Authorized Field Change

AFC G-03908 Revised

Subject: Front Cover and Oil Cooler Header Gasket Resiliency Depletion on International® DT 466 and 530 Engines Built Between August 1, 2000 and January 22, 2004

Figure 1 "Silicate Added" Label

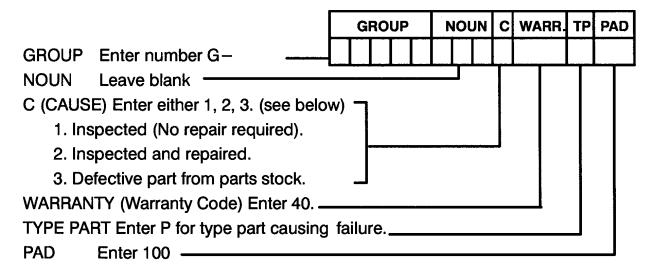
2. Locate and clean an area on the radiator reinforcement as near coolant fill cap as possible.

Apply the "Silicate Added" label provided in the kit (Figure 1).

3. RE/ FE Bus Only: Locate and clean an area near the radiator fill tube.

Apply the "Silicate Added" label provided in the kit (Figure 1).
